**United States Patent and Trademark Office**

09/484,421 01/18/00 DUBS

# Office Action Summary

FIG. 1

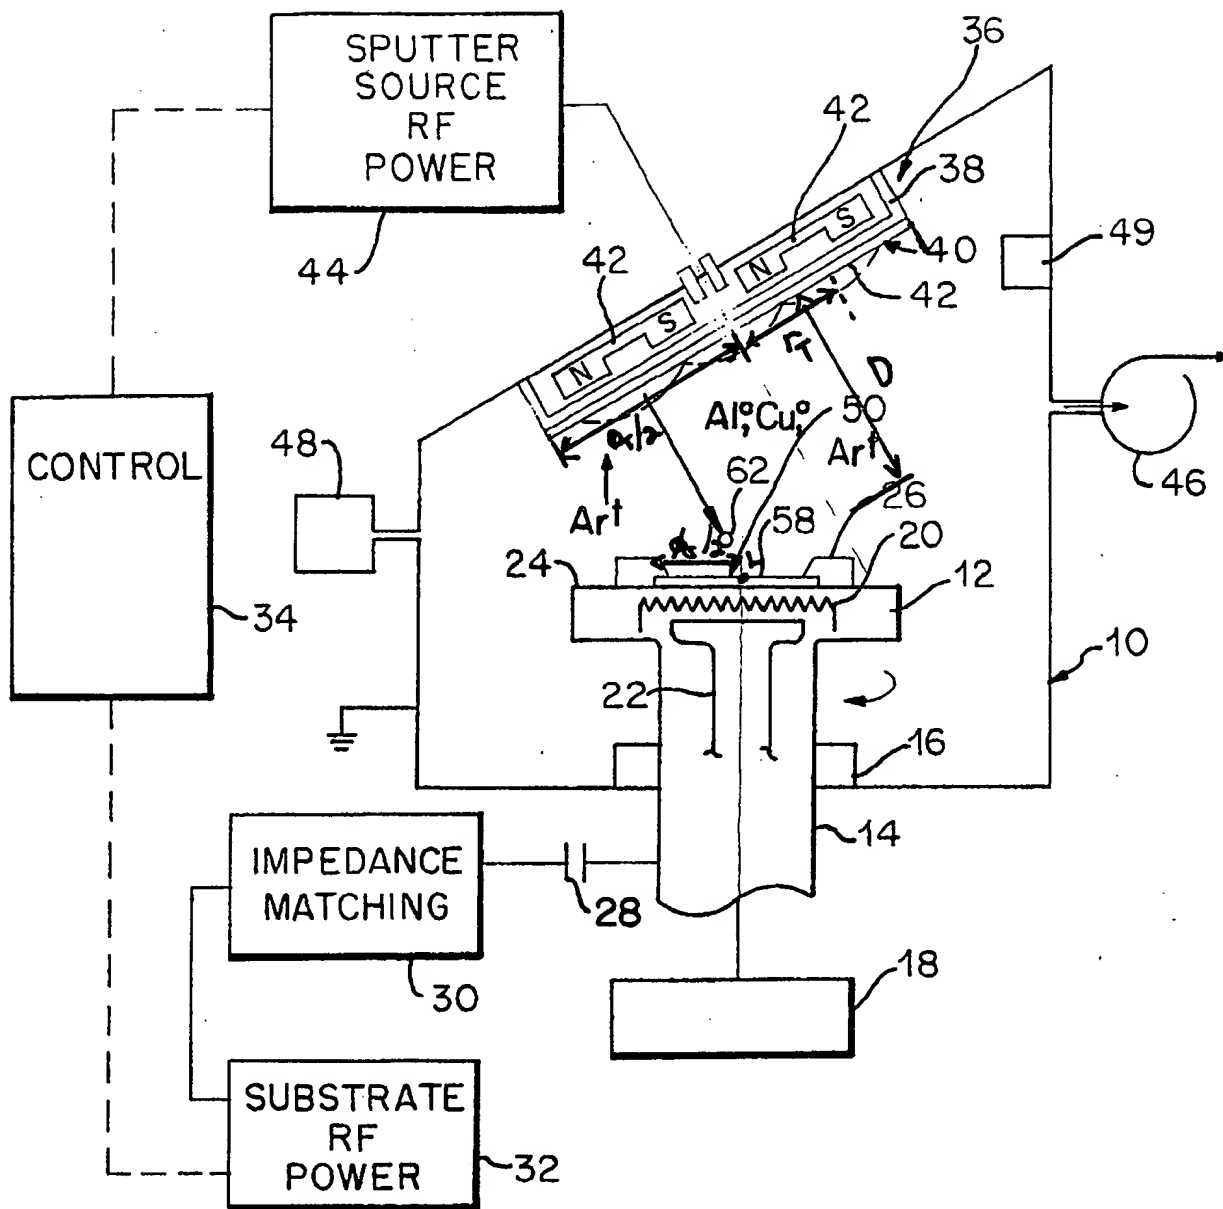
The axes which defines each of the target and substrate carrier are infinite along the plane which defines each of these axes. Since the axes are oblique, they will intersect (see attached marked up copy of Fig. 1 as applied to claim 3). The angle of the target surface relative to the substrate carrier is between 30 and 60° (Fig. 1 and col. 7, lines 49-51 as applied to claim 4). The substrate carrier is positioned horizontally relative to the bottom of the chamber (as applied to claim 6). The target surface is greater than the substrate to be coated (Fig. 1 as applied to claim 7).

Lamont has an inherent distance  $D$  (the smallest spacing between the central axis and the substrate carrier from the sputter surface) and the radius  $r_T$  (the largest erosion depth profile) which would be in the central region of the outer magnetic field lines (See Fig. 1). Given that Lamont inherently has these two features in the same configuration as the instant claims and that the approximated distance  $D$  as compared to the radius  $r_T$  is about twice as great, one of ordinary skill in the art would expect this configuration to result in an inherent ratio between  $\frac{1}{4}$  and  $\frac{2}{3}$  (as applied to claim 9). As well given the relative relationship of distance  $D$  in comparison to the diameter of the target, one of ordinary skill in the art would expect that the target diameter would be about twice as great as the smallest distance  $D$  (as shown in marked up copy of Fig. 1 as applied to claim 10). Distance  $D$  appears to be about the same length as that of the substrate diameter and would inherently arrive at a ratio of 1.8 or less (as applied to claim 11). The diameter of substrate receiving surface is about half the diameter of that of the target (as applied to claim 12).
